**ATTACHMENT 2:  
AGENCY CORRESPONDENCES**

**Sycamore-Penasquitos 230kV Project**  
**SDG&E/City of SD Meeting**  
**Friday, January 22, 2016 – 9:00AM – 10:30AM**  
**CoSD Engineering Field Division Office**

**Subject:** RE: Sycamore-Penasquitos 230-kV Transmission Line Project EIR review

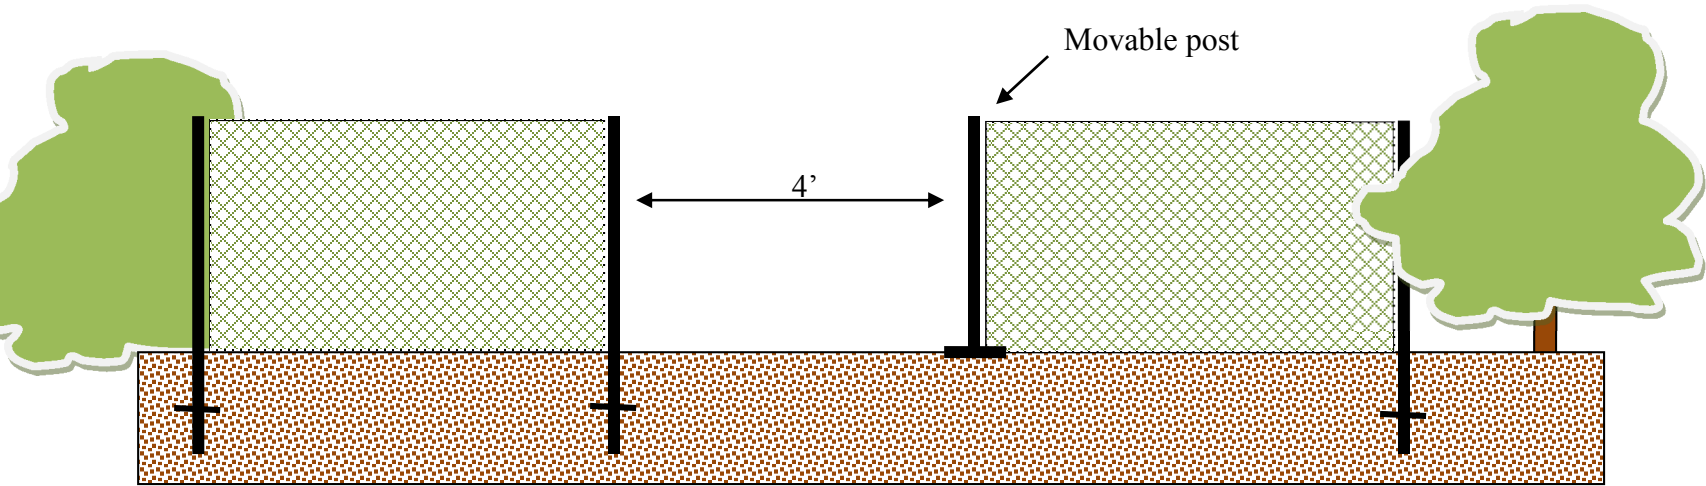
I'm sorry Leo I thought I'd responded to you but apparently I just sent you a blank email. The road you are suggesting to block off is both a major recreational trail and maintenance/emergency access for ranger staff. We would need to come up with a solution that allowed unhindered bicycle/hiker/equestrian access during the day and movable vehicle access. A 4' wide opening would suffice for the trail access.

I've attached a map showing good places for the barrier and an illustration of what I'm talking about. We would also prefer that green "snow fencing" be used instead of orange. Orange is always perceived as development and loss of trails/habitat. Making it green is a small thing for good p.r.

4' wide trail opening and movable gate
